Wheel Horse Service Bulletins 1961 - 1990: **#102** Issued: August 1968
**Ignition Switch and Wire Kit #6083 - 1968 10 & 12 H.P. Models with
10 AMP. Alternators**

Wheel Horse Service Bulletins 1961 - 1990: #134 Issued: February 1972

Ignition Switches - 1972 Models

Wheel Horse Service Bulletins 1961 - 1990: **#325** Issued: March 1982

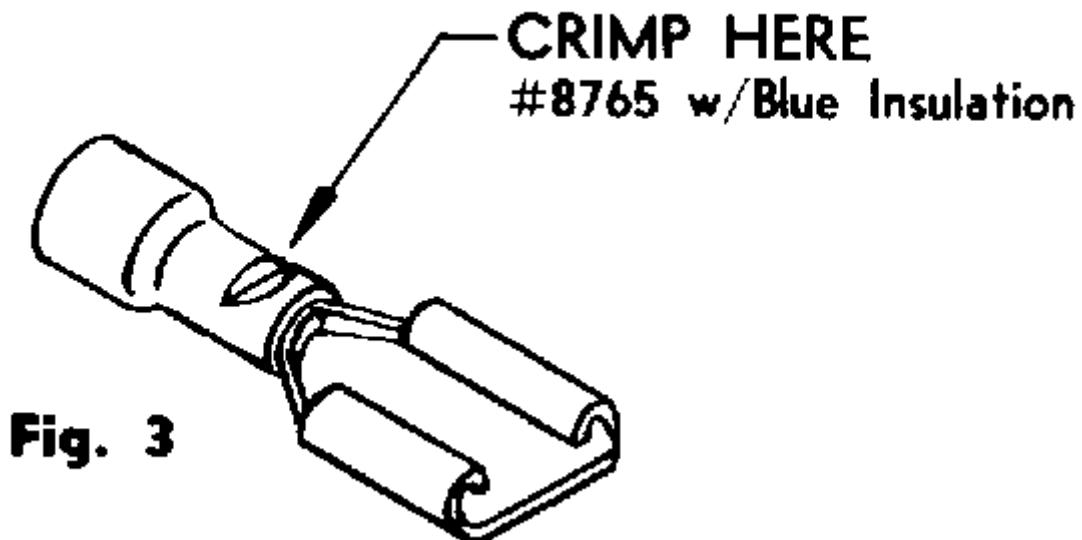
A new improved Ignition Switch, Part #8362 has been developed and is now available in a kit making it adaptable to all 1968 10 and 12 H.P. model tractors with 10 Amp. alternator.

This switch provides 4 positions as shown in Fig 1.

The key must be manually moved from the Run position to the Run and Accessories position before current is supplied to the lights, cigar lighter, or electric clutch, if so equipped. The battery is charged in both the Run and the Run and Accessory position.

In the OFF position the system provides protection from the battery running down due to any accessory being left on and from any possible drain through the rectifier-regulator to ground.

If it is determined that abnormal battery drainage exists through the rectifier-regulator unit we recommend that the ignition switch and wire kit #6083 be installed. NOTE: Make sure that the charging system charges properly as the new type switch will not correct a faulty unit such as a bad battery, regulator or stator. Refer to Wheel Horse Service Bulletin #95 and the related Kohler and Lauson Service Bulletins.

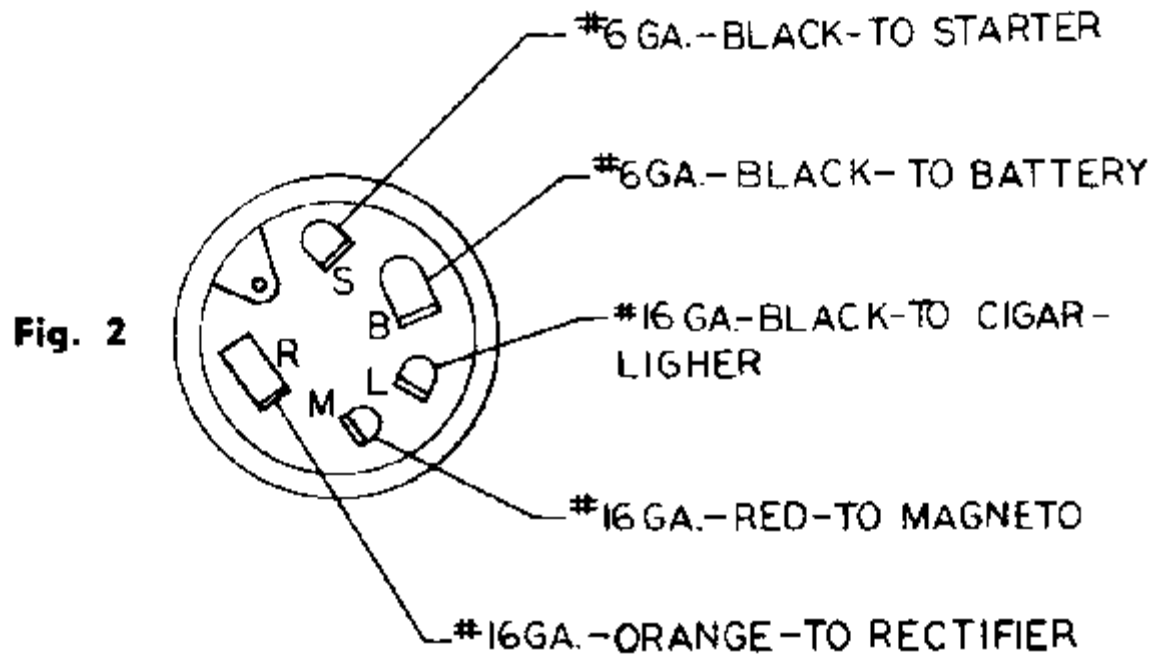
10. Install the 9/16" diameter lock washer and the plastic insulator over the threaded switch hub and position the switch in the instrument panel. Install the switch retaining nut and tighten securely while holding the switch body from turning, making sure switch key slot is vertical. NOTE: The large #6 Battery and Starter wires have a tendency to distort the switch terminals if they are misaligned. Make sure all terminals are tight and insulated from each other. Recheck wiring making sure it checks with Fig. 2.

7953 PINION

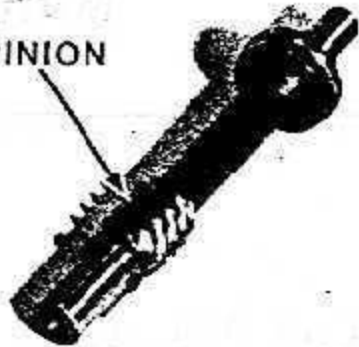
2.1 The replacement face gear is our P/N 105176. Be sure to examine the pinion, P/N 7953, very carefully. It should be replaced if **ANY** damage is noted; otherwise, the new face gear may be ruined.

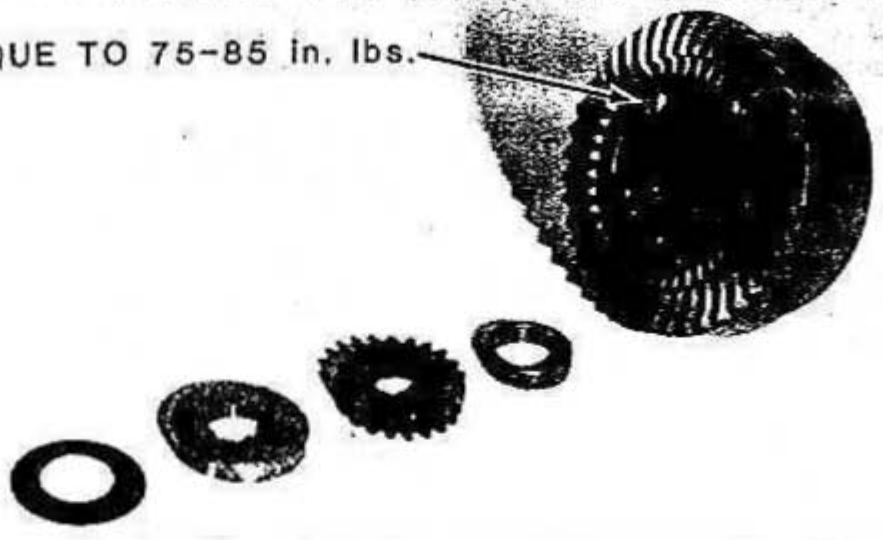
ALL OTHER PARTS MUST BE
IN SERVICEABLE CONDITION

TORQUE TO 75-85 in. lbs.

TRANSAXLE LUBRICANT SAE 90 GL-4 or 5
